#### IN THE DRAWINGS

Applicant has amended Figures 1 and 4 as indicated by the highlighting in pink highlighter on the enclosed drawing sheets.

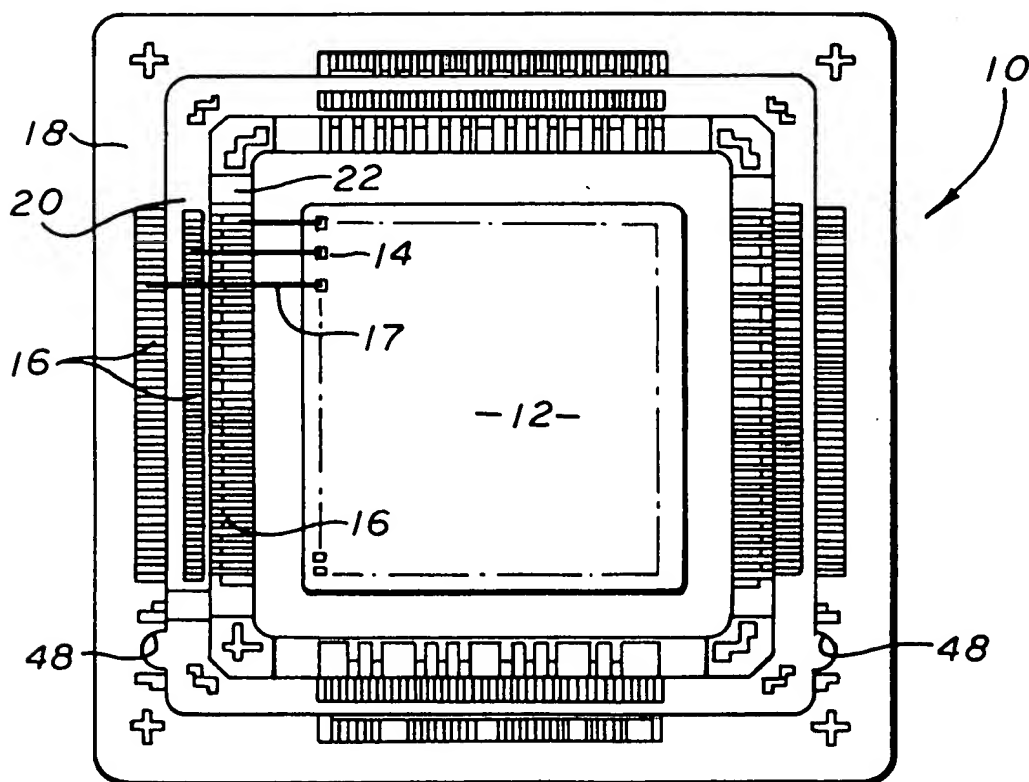
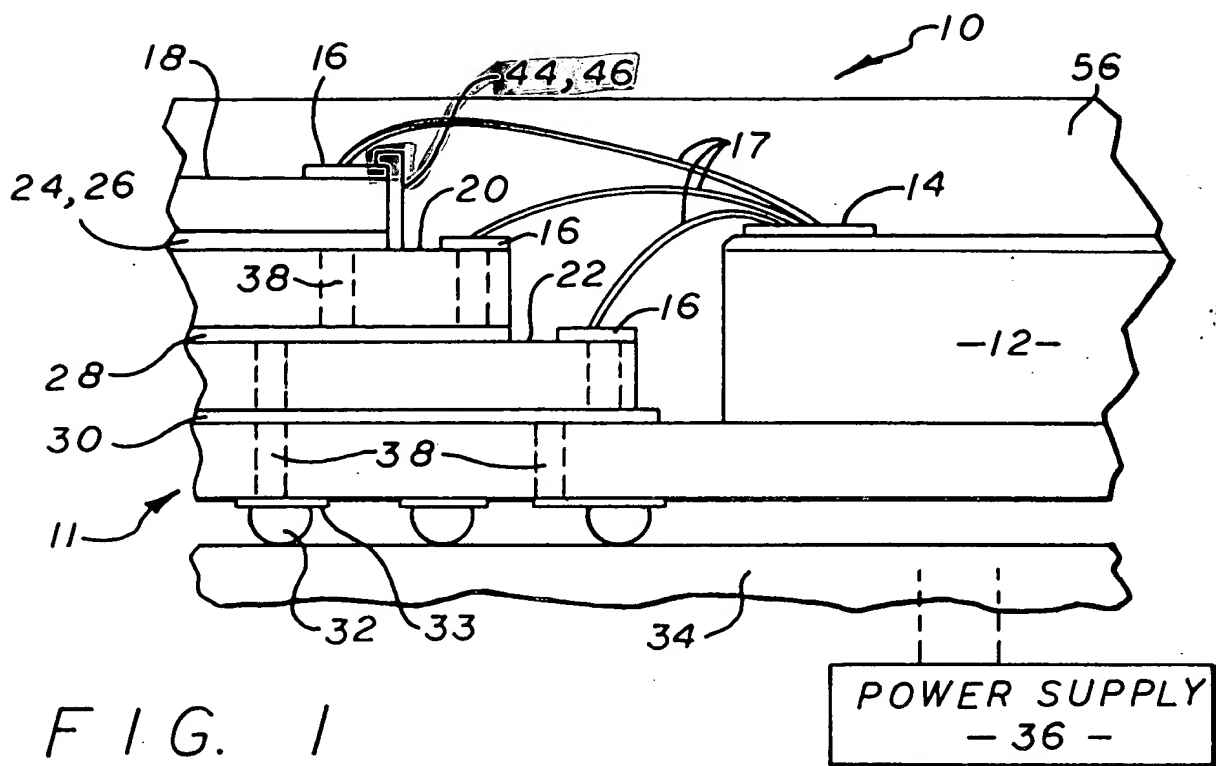
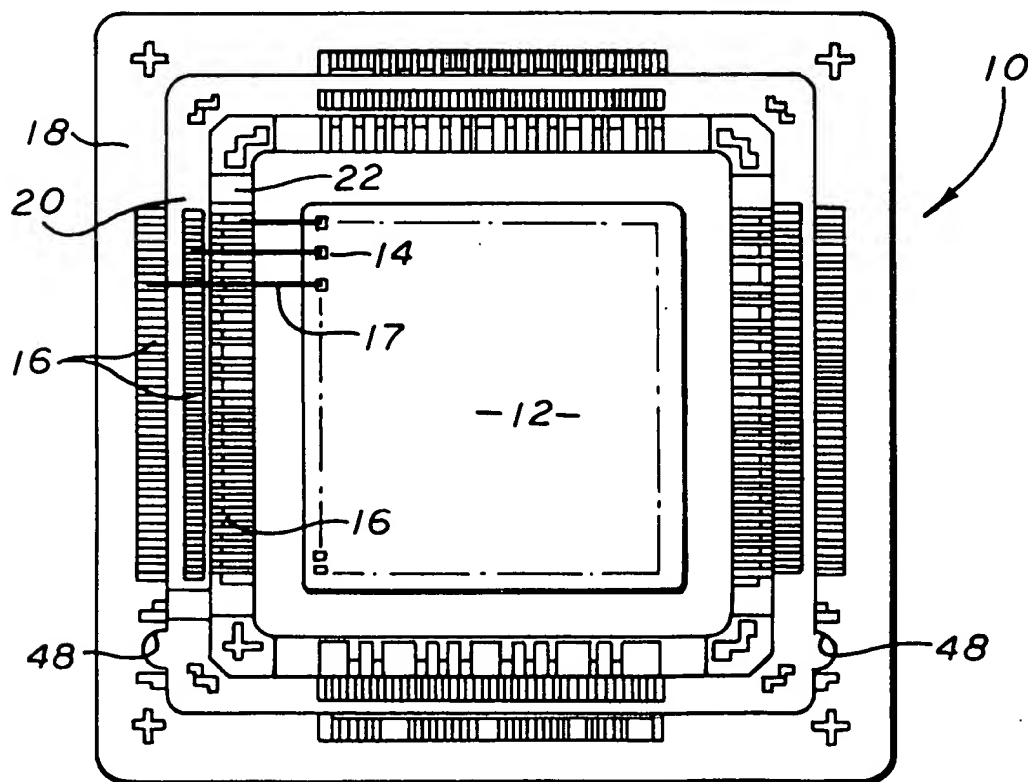
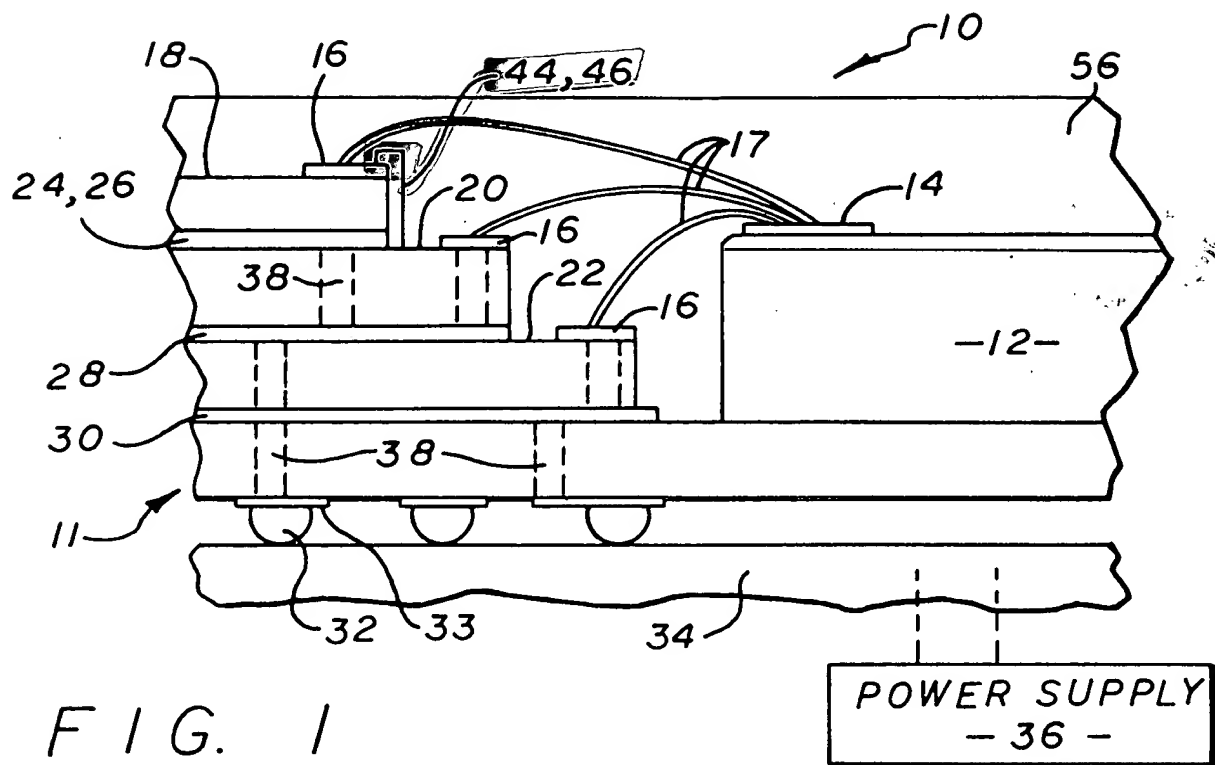
In Figure 1, the reference designators 44 and 46 ("44,46") are added to the conductive strip at the edge of the first bond shelf 18. Dashed lines between the pad 16 and busses 24,26 are deleted. The connection between the conductive strip 44,46 and the bond pad 16 is amended to be clearly shown in accordance with Figure 7.

FIG. 4

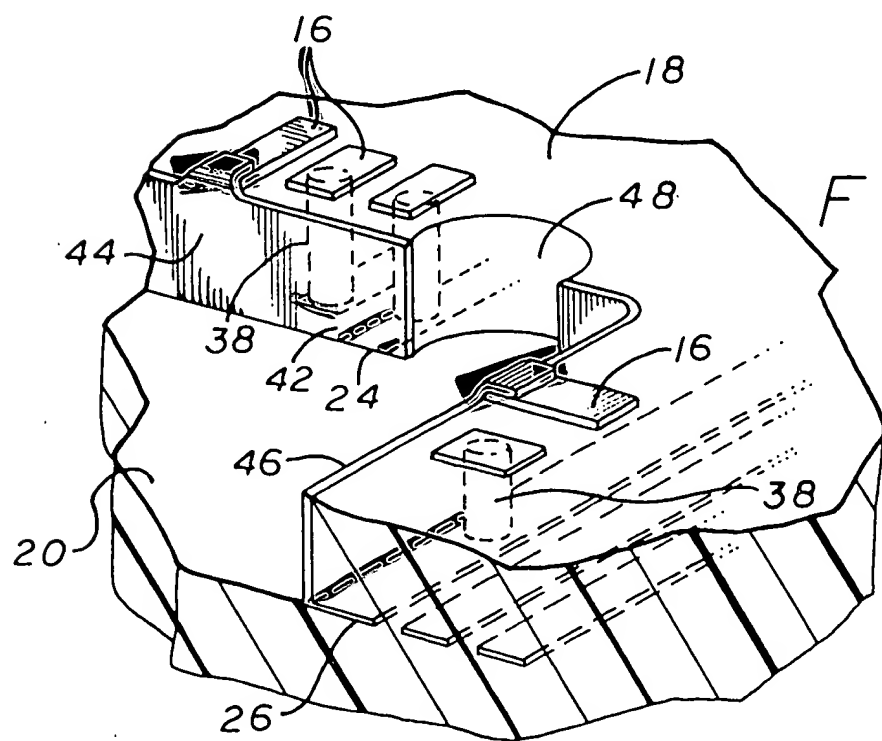
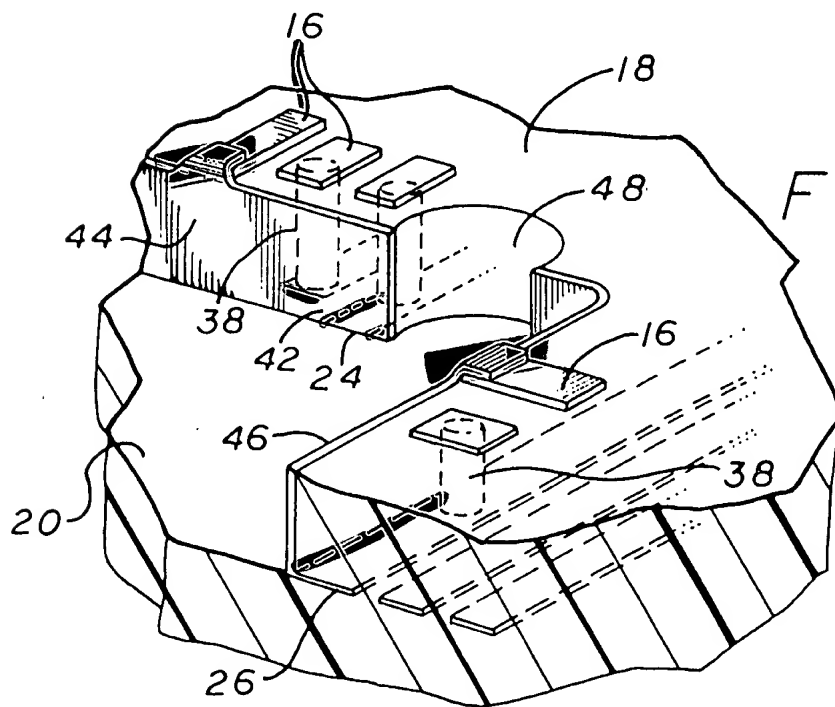
In Figure 4, the end of busses 42, 24, are amended to more clearly show how bus 24 connects to strip 44 in accordance with Figure 1. The width of bus 26 is amended to more clearly show how bus 26 connects to strip 46. The connection between the conductive strip 44,46 and the bond pad 16 is amended to be clearly shown in accordance with Figure 7.
